Response to Submissions and Amendments to Proposed Development

Sydney International Convention, Exhibition and Entertainment Precinct (SICEEP)

The Haymarket, Residential Building (Student Accommodation)

Submitted to Department of Planning and Infrastructure
On Behalf of Lend Lease (Haymarket) Pty Ltd

Figure 4 – Land to be transferred to SHFA

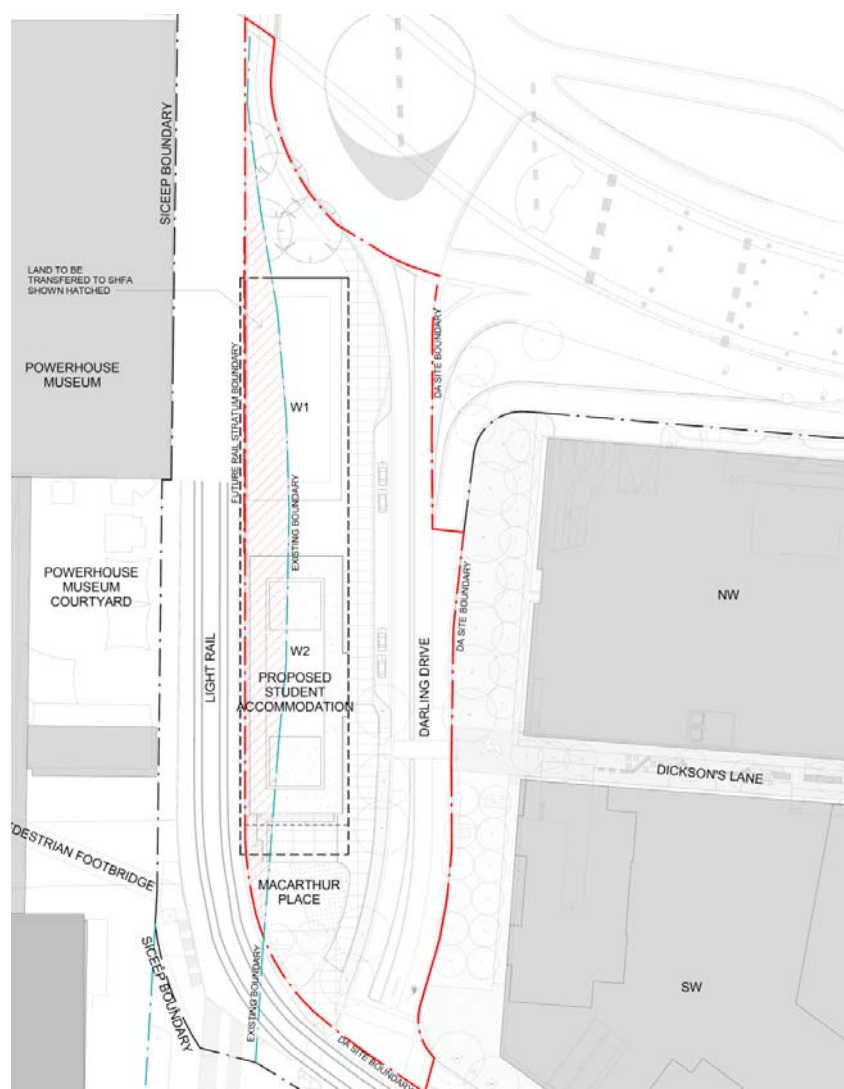
The Department has raised several considerations relating to the traffic and transport arrangements of the proposal. Several of these matters sought clarification on elements of the proposal, such as whether any coach parking would be provided within the site and what the impact of the proposal would be on the stratum of air space over the light rail corridor.

There is not expected to be any impact on the stratum of air space over the light rail corridor. Following discussions between TfNSW and SHFA, a portion of the current light rail corridor will be transferred to the ownership of the Sydney Harbour Foreshore Authority to ensure no future conflict occurs (see **Figure 4**). Building W2 will be contained entirely within SHFA owned land.
